**STAFF REPORT**

**FDPA 81-S-058-01-01**

**FDPA PROPOSAL:** The applicant seeks approval of an amendment to a Final Development Plan (FDP 81-S-058-01), to redevelop an existing 2-story 4,861-square foot community clubhouse with a 2-story 10,860 square foot community clubhouse for the Lakeside Apartment complex.

**Sheet 9** is the RPA Impervious Exhibit, which shows approximately 14,295 square feet of the existing impervious area in the RPA, as well as an approximate 13,700 square feet of proposed impervious area within the RPA. The sheet also includes a resource protection area narrative.

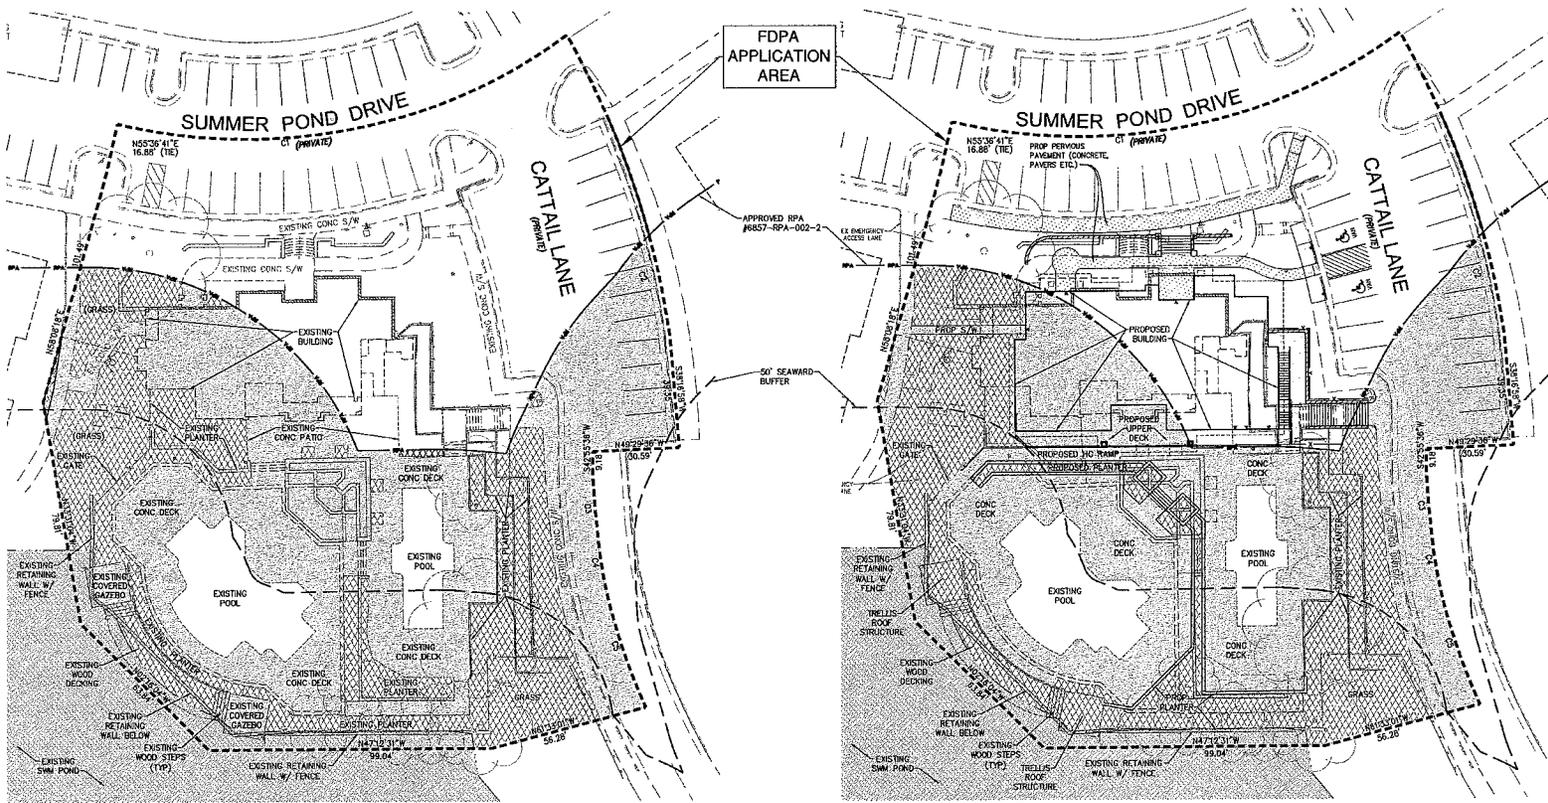
The existing building and site improvements were built in 1988, preceding the adoption of the Chesapeake Bay Preservation Ordinance (CBPO). The Resource Protection Area (RPA) shown on the proposed plans was approved by Fairfax County pursuant to 6857-RPA-002-2 on January 31, 2014. Approximately 1,686 square feet of the existing clubhouse building is located within the RPA. The proposed clubhouse will reduce the development's overall impervious area in the RPA by approximately 832 square feet, from an existing 14,295 square feet to a proposed 13,463 square feet.

Staff reviewed the applicant's proposal and concluded that provided there is no increase in the amount of impervious cover and no further encroachment within the RPA, the proposed plan will qualify as "re-development", per CBPO 118-2-1, and the proposal is in accordance with the conditions in CBPO Article 5, 118-5-4(a), specifically that: the encroachment does not extend into the seaward 50 feet of the buffer area, the proposed development does not exceed 10,000 square feet of land disturbance in the RPA buffer, and does not create more than 5,000 square feet of impervious surface within the RPA buffer, exclusive of access to the lot or parcel and principal structure pursuant to Sect. 1118-2-1(d.) Staff also requested a Water Quality Impact Assessment ("WQIA"), which was submitted by the applicant. For land disturbing activities that result in no net increase in impervious cover from the pre-development condition, the total phosphorous load must be reduced at least 10 percent below the pre-development total phosphorous load, per Chapter 124-4-2(a)(2b). The total phosphorous load is not required to be reduced below the applicable standard for new development, per Chapter 124-4-2(a)(2e). The applicant must provide a copy of Virginia Runoff Reduction Spreadsheet that shows how this requirement is to be met. A full analysis of the Storm Water capacity of the pond must be provided at the time of the final site plan. If the pond is determined to be insufficient, an additional BMP will be required to be provided to meet the 10 percent reduction; per DEQ Guidance Memo 14-2014, the pond can continue to be used to provide BMP.

In response to staff recommendations, the applicant has reconfigured the development's proposed layout to reduce the amount of impervious area; therefore, the conditions of

**Sheet 10** is the existing storm water management pond plan.

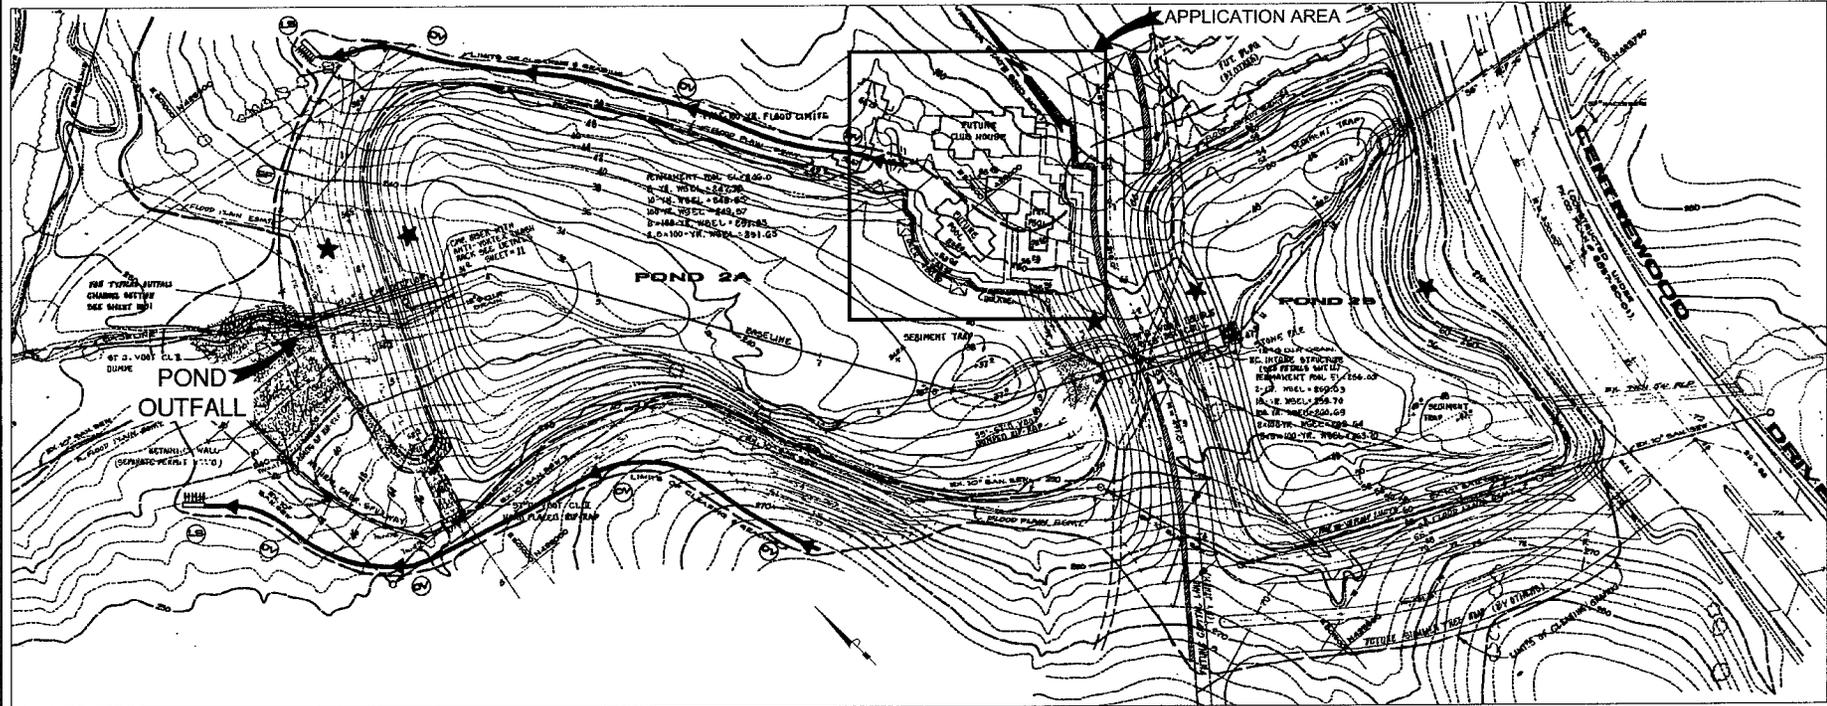
With the change in the state regulations and Chapter 124 the design requirements for wet ponds changed. Specifically, the design storm. The requirement is to size the facility using the 24 hour storm; the computations on sheet 10B use the 2 hour storm is the old Public Facilities Manual requirement. The applicant should provide computations to show how this detention requirement is met. Chapter 124-4-4(d).
